REMARKS/ARGUMENTS

PROPOSED DRAWING AMENDMENTS
FOR SN 10/812,918

AMENDMENTS TO THE DRAWINGS

FIG. 1
(PRIOR ART)

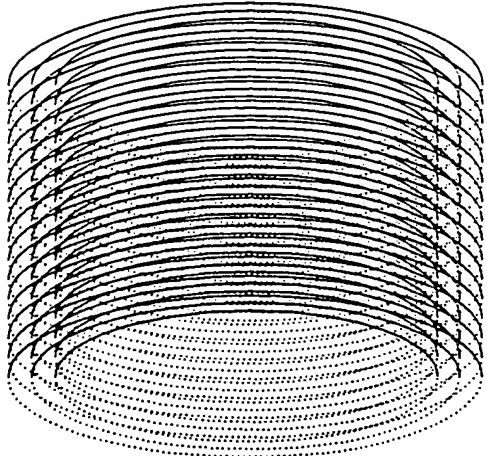
Proposed amendments adding “prior art” legends to Figures 1 and 2a in red ink are attached together with proposed new substitute drawings incorporating those changes.
